Department of Planning, Housing and Infrastructure

Riverstone East – Stage 3 Finalisation Report

May 2025

Figure 12: Final ILP - amendments following exhibition

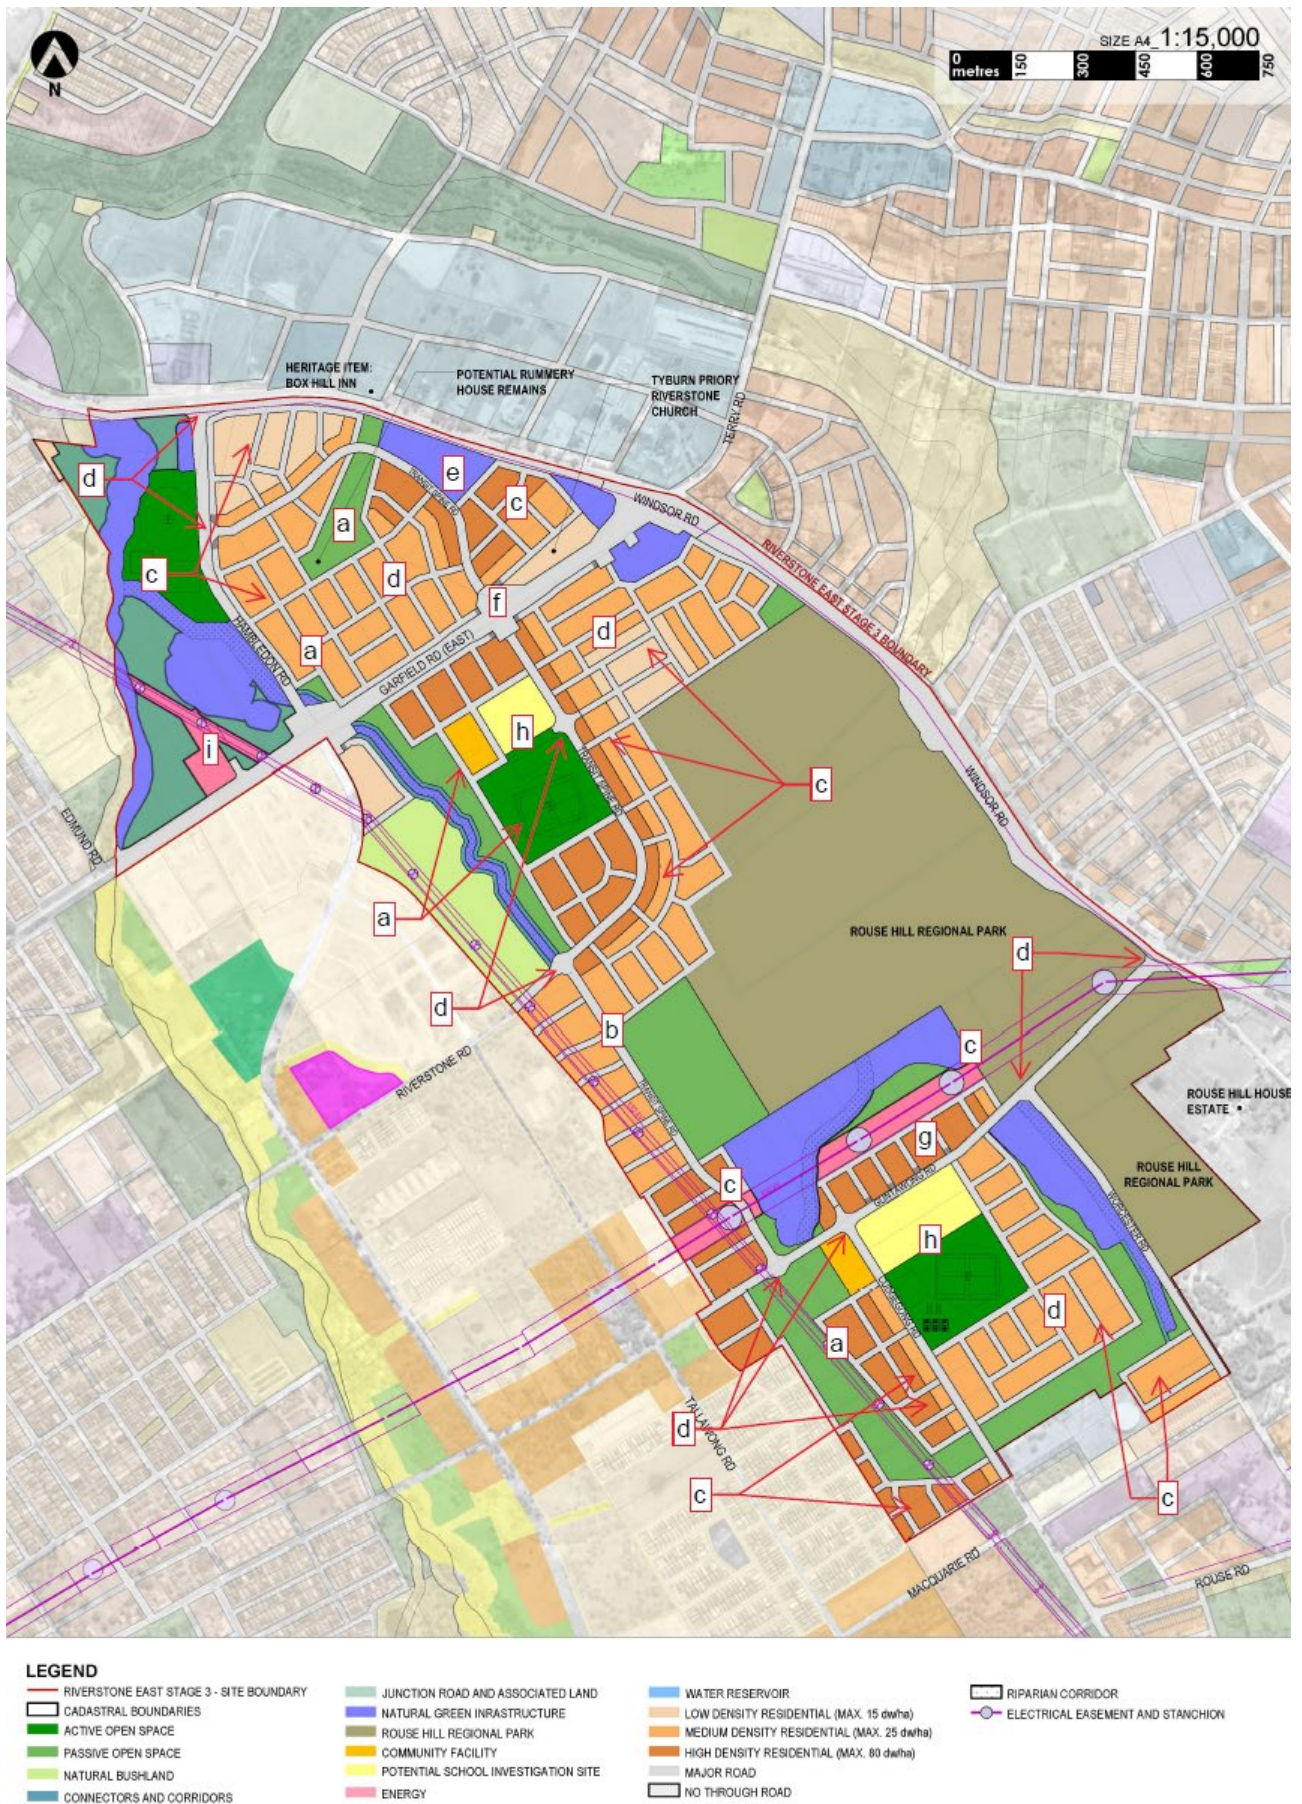
Since the exhibition, amendments have been made to the ILP to respond to issues raised in submissions. **Table 7** provides an explanation of the rationale for the changes made to the final ILP (shown in **Figure 12**).

Description of change	SEPP map/s amended	Explanation	Figure notation
Public open space and community facility adjustments: Reduced passive open space in north and northeast; extended central active open space; reconfigured northern community facility and southern passive open space	Zoning, Acquisition	Updated based on heritage advice, landowner submissions, drainage requirements, and Council concerns	a
Transit spine realignment: More direct north-south route; removal of adjacent small passive open spaces	Zoning, Acquisition	Improves transit efficiency; maintains exhibited alignment as local street for APZ to RHRP	b
Residential density changes: Redistribution of low, medium, and high-density areas; removal of R4 zoning	Zoning, Residential density, Height of Building	Responds to submissions, feasibility concerns, topography constraints, and NWGA zoning norms	c
Local street network modifications: Realignment and removal of some streets; mapped roundabouts and intersections	Zoning, Acquisition	Based on submissions, density redistribution, and need to protect intersection requirements	d

Riverstone Road extension adjustment: Minor alterations north of Garfield Road East	Zoning, Acquisition	Reconfigured for local street network changes and potential Rummery House remains	e
New streets parallel to Garfield Road East	N/A	Improves urban design outcomes and usability of adjacent land	f
Guntawong Road modifications: Removal of four intersections; widened reservation for bus services	Zoning, Acquisition	Reduces intersections, maintains pedestrian connections, enables bus network flexibility	g
School and open space street removal: Eliminated streets between potential schools and active open space	Zoning, Acquisition	Improves integration of educational and recreational spaces	h
Electricity substation adjustment: Removal of Lot 100 DP 1282712	Zoning, Acquisition	Responds to Endeavour Energy submission	i
Road zoning changes: Cudgegong and Worcester Roads rezoned to R2 from SP2	Zoning, Acquisition	Aligns with adjacent Area 20 Precinct zoning	N/A
